Work Order ID 105910

Item Name: Fwd Crosstube - High

DART AEROSPACE LTD		Work Order:	105910
Description: Crosstube High Fwd (205/212/412)		Part Number:	D212-664-101
Inspection Dwg: D212-664-141 Rev: D		Page 1 of 1

DRAWING NO. D212-664-141	TITLE XTUBE ASSY (205/212/412 HI FWD)	REV. D	DART AEROSPACE LTD ENGINEERING ORDER		D.E.O. NO. D212-664-141-D-1	SHEET NO. SHEET 1 OF 2	SCALE NTS
DRAWN	CHECKED	MFG. APPR.	APPROVED	DE APPR.			
DATE 11.04.07	DATE 11.04.11	DATE 11.04.12	DATE 11/04/12	DATE 11.04.12

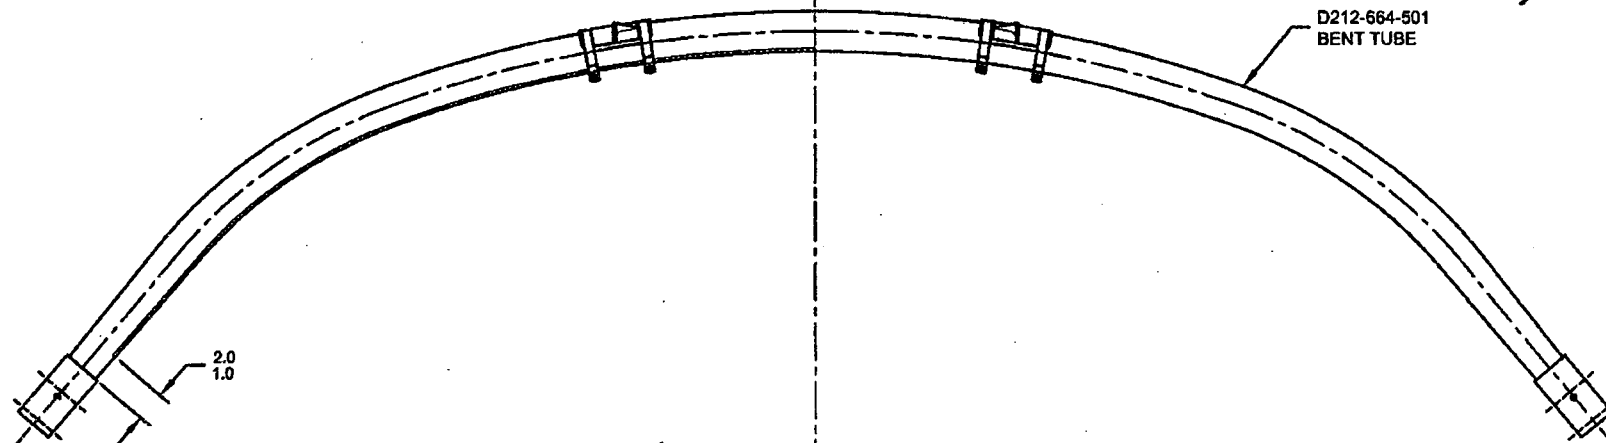
ADD AN INSPECTION WINDOW TO UNDERSIDE OF CROSSTUBE.

NOTES 2 OF SHEET 1 IS AMENDED AS FOLLOWS:

- 2) FINISH: CHEMICAL CONVERSION COAT PER DART QSI 005 4.1
PRIME INSIDE AND OUTSIDE PER DART QSI 005 4.2
MASK UNDERSIDE OF CROSSTUBE AS SHOWN (HATCHED AREA) AND
PAINT OUTSIDE PER DART QSI 005 4.2
REMOVE MASKING AND APPLY CLEAR COAT

MASK AREA PRIOR TO PAINTING,
REMOVE MASKING AFTER PAINT
AND APPLY CLEAR COAT
